Addendum No. 2

Date:	May 30, 2013
To:	Contractors
From:	Rick James - Project Manager
Reference:	George S. Eccles Student Life Center University of Utah – Salt Lake City, Utah DFCM Project No. 08015750
Subject:	**Addendum No. 2**

2.2 **GENERAL ITEMS**: See attached Architect's Addendum No. 1 dated May 28, 2013.

1 C ENLARGED LEVEL 2 POWER PLAN WEST
EP102.C SCALE | 1/8" = 1'-0"

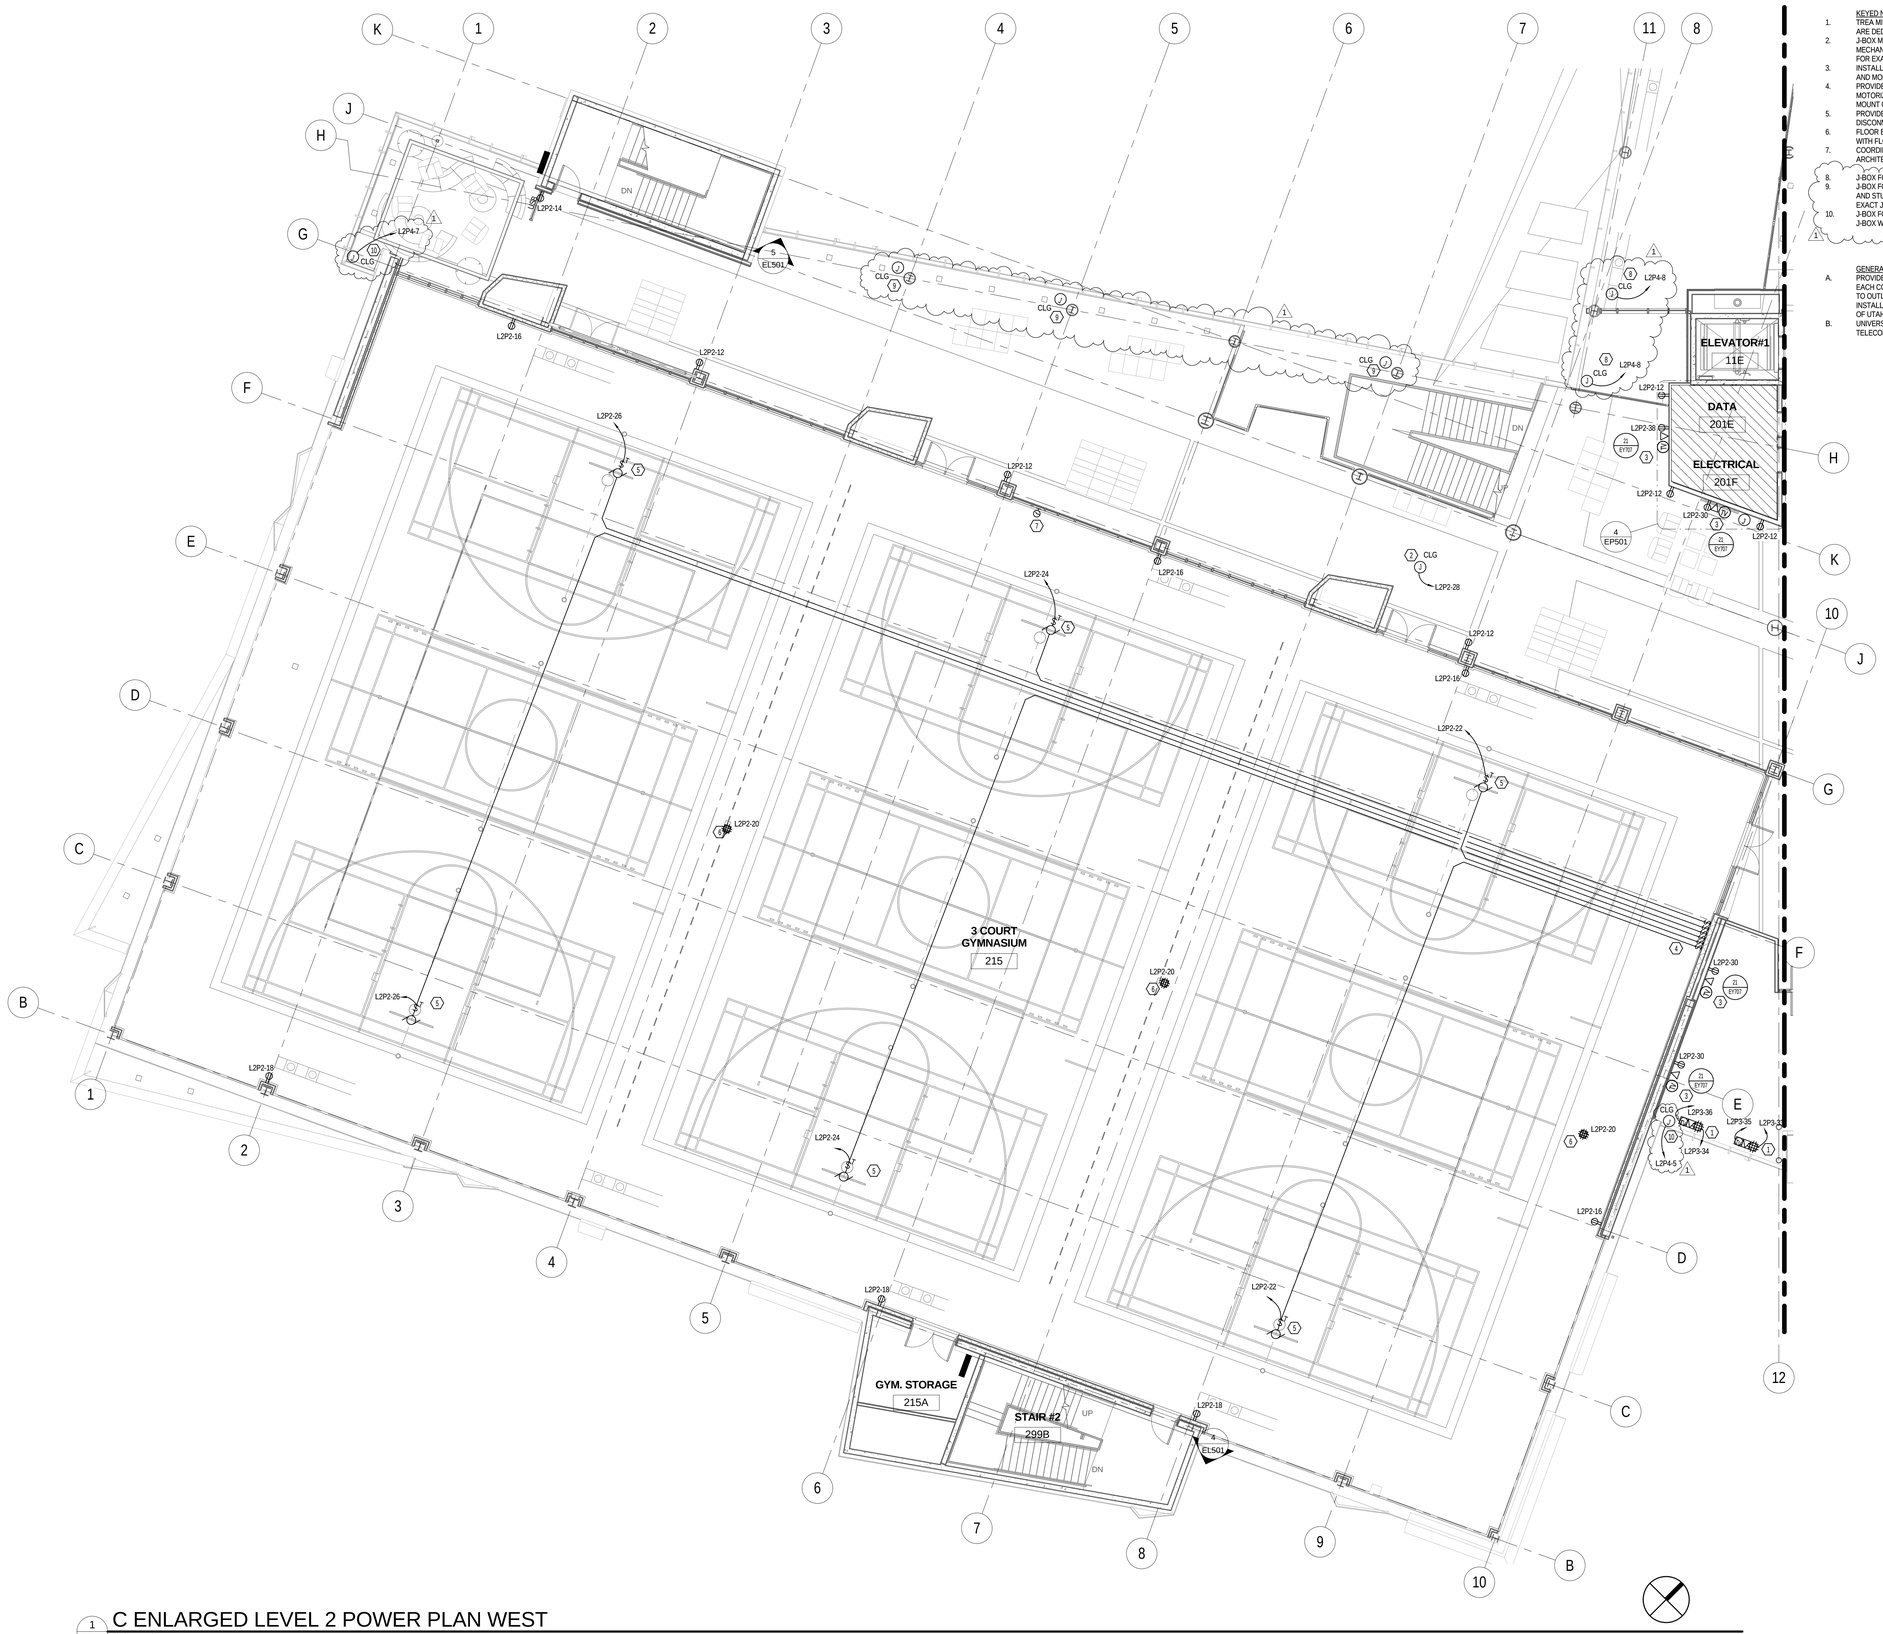
1. Add: Keyed Note #8 – See attached sheet EP102.C
2. Add: Keyed Note #9 – See attached sheet EP102.C
3. Add: Junction boxes in various locations for motorized shades and future motorized shades. See attached sheet EP102.C for locations.

1 EP103.A A ENLARGED LEVEL 3 POWER PLAN NORTH
SCALE |1/8" = 1'-0"

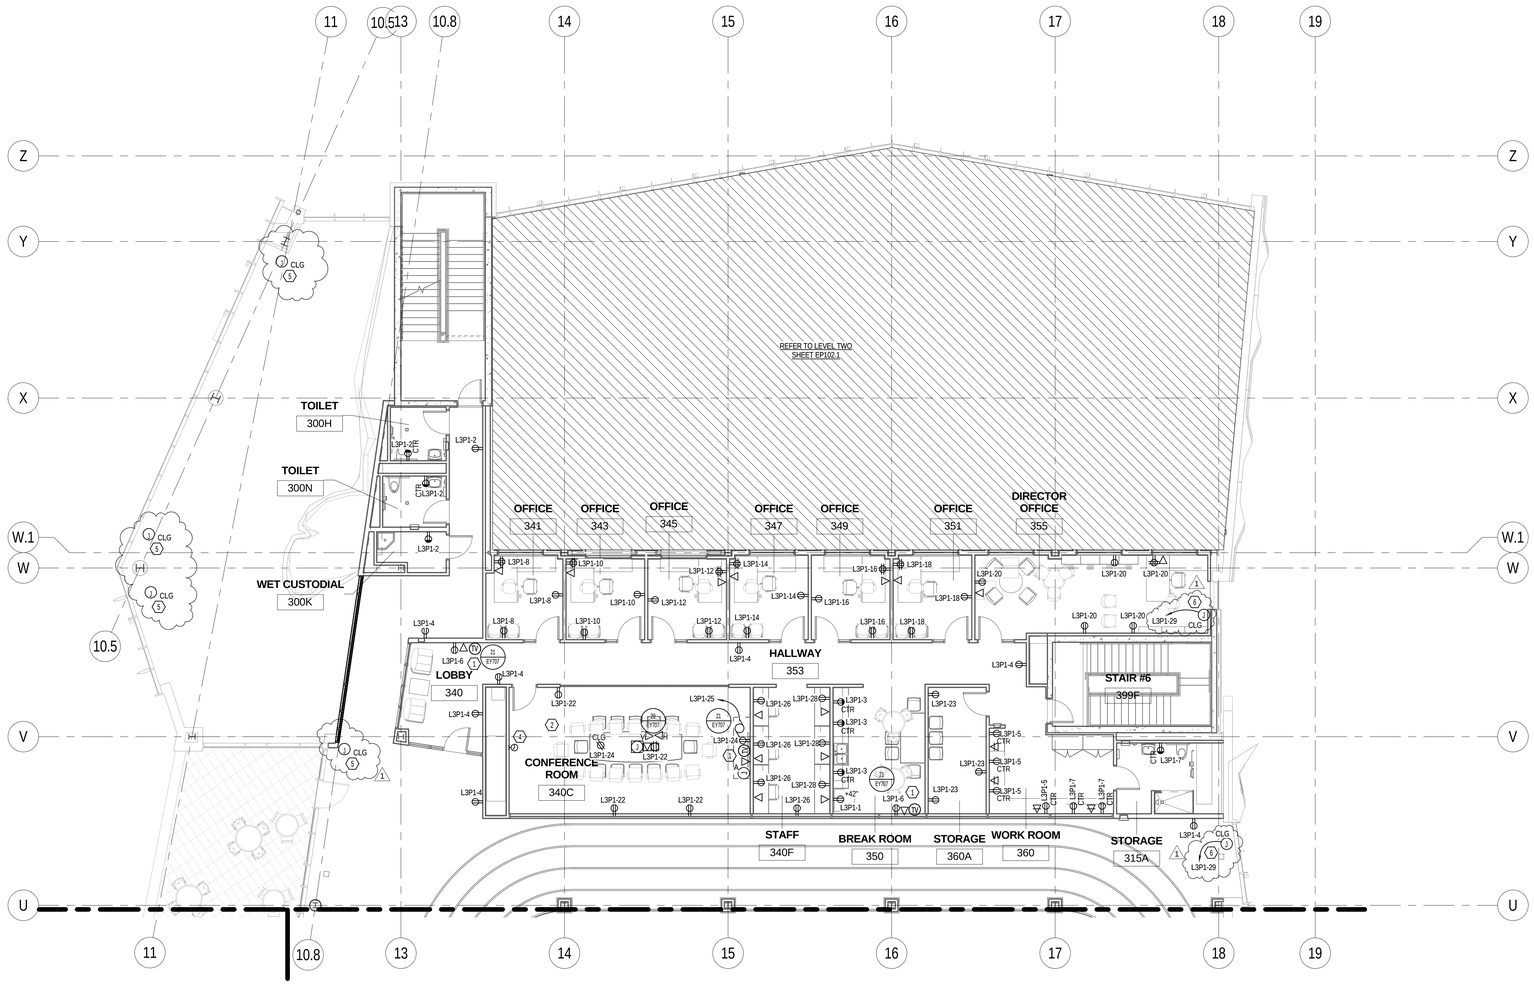
1. Add: Keyed Note #5 – See attached sheet EP103.A
2. Add: Keyed Note #6 – See attached sheet EP103.A
3. Add: Junction boxes in various locations for motorized shades and future motorized shades. See attached sheet EP103.A for locations.

1 EP103.B B ENLARGED LEVEL 3 POWER PLAN SOUTH
SCALE | 1/8" = 1'-0"

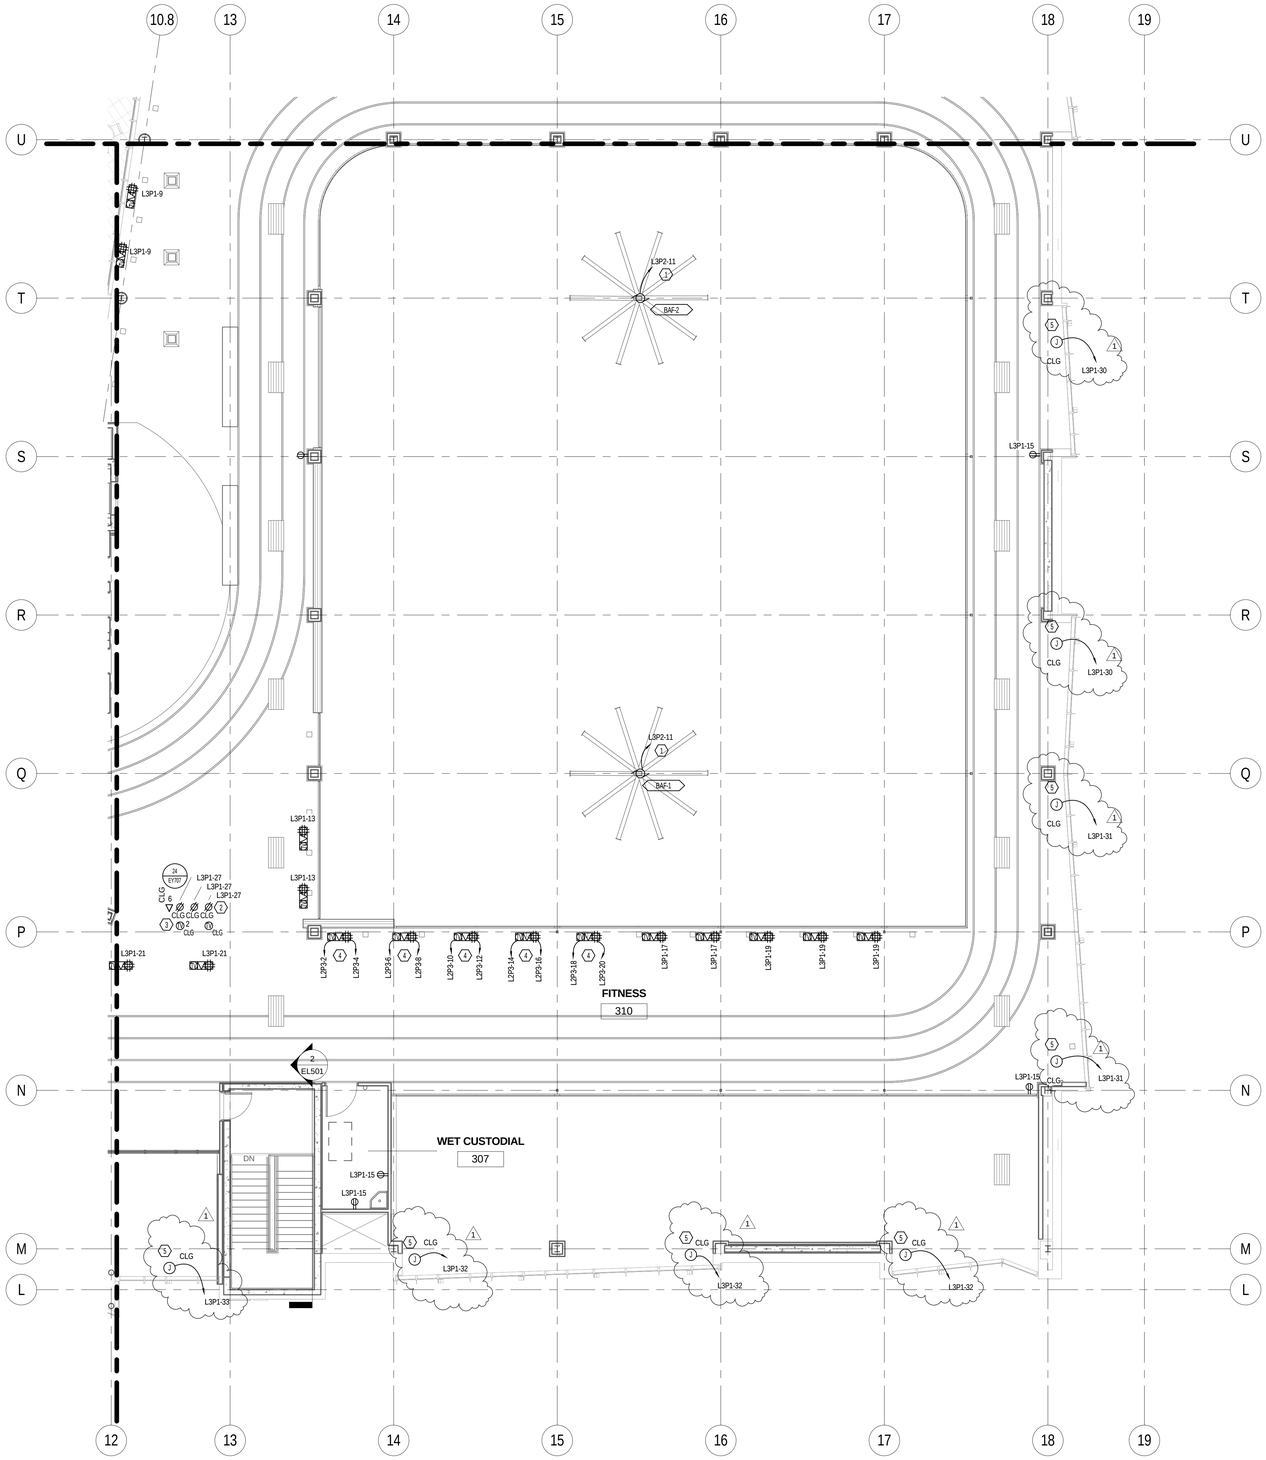
1. Add: Keyed Note #5 – See attached sheet EP103.B
2. Add: Junction boxes in various locations for motorized shades and future motorized shades. See attached sheet EP103.B for locations.

1 EP103.C C ENLARGED LEVEL 3 POWER PLAN WEST
SCALE |1/8" = 1'-0"

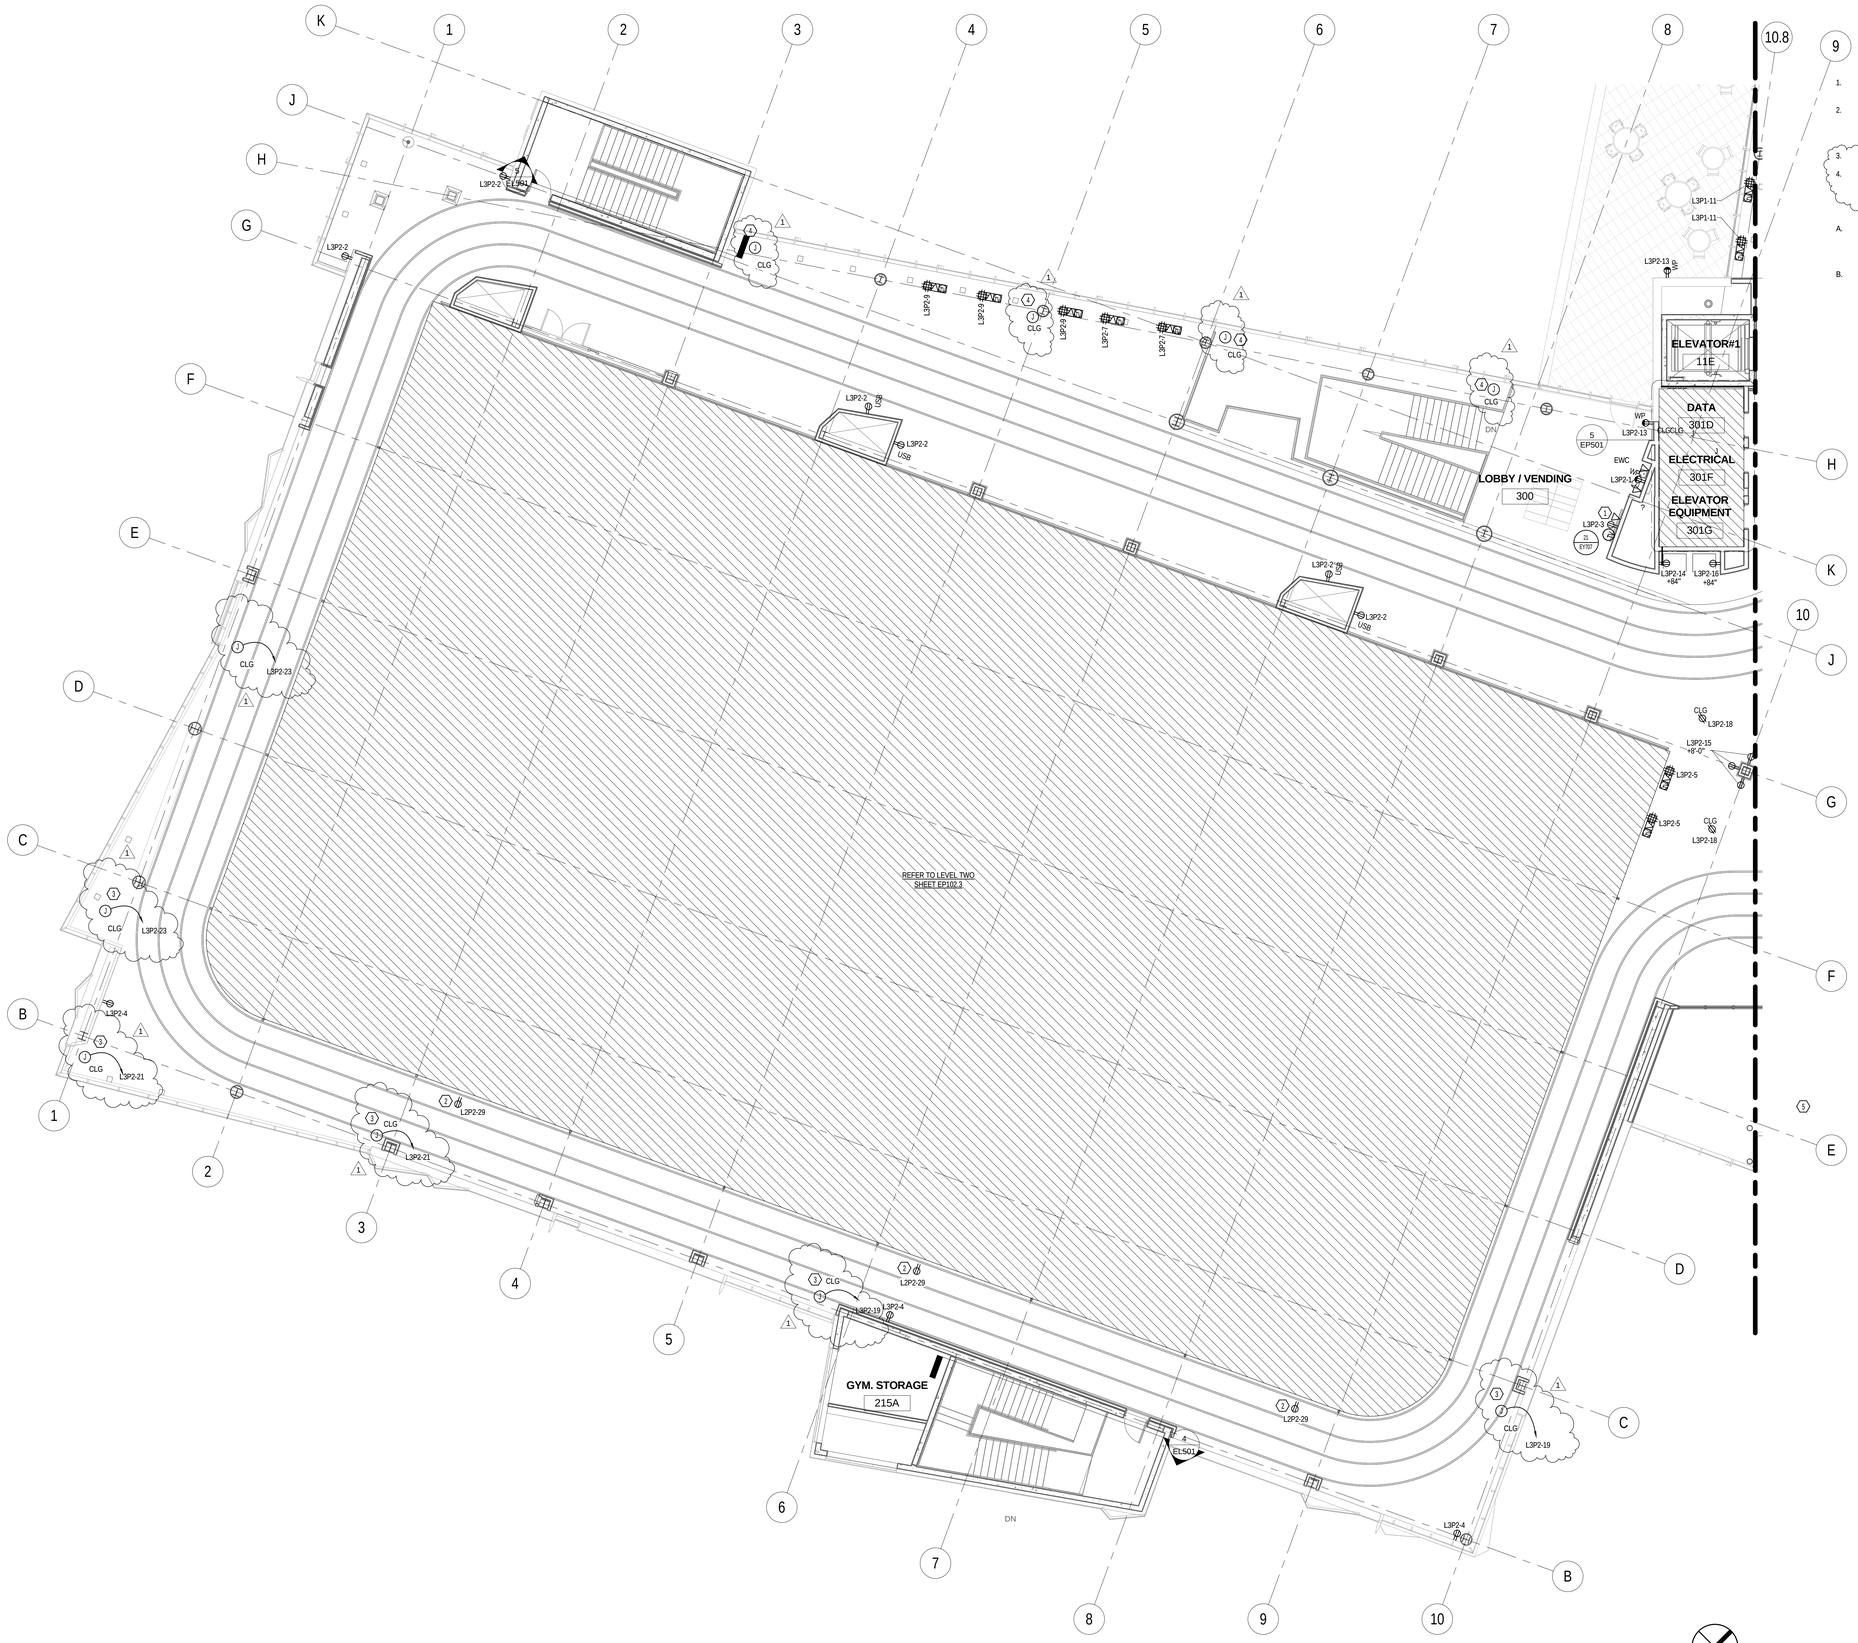
1. Add: Keyed Note #3 – See attached sheet EP103.C
2. Add: Keyed Note #4 – See attached sheet EP103.C
3. Add: Junction boxes in various locations for motorized shades and future motorized shades. See attached sheet EP103.C for locations.
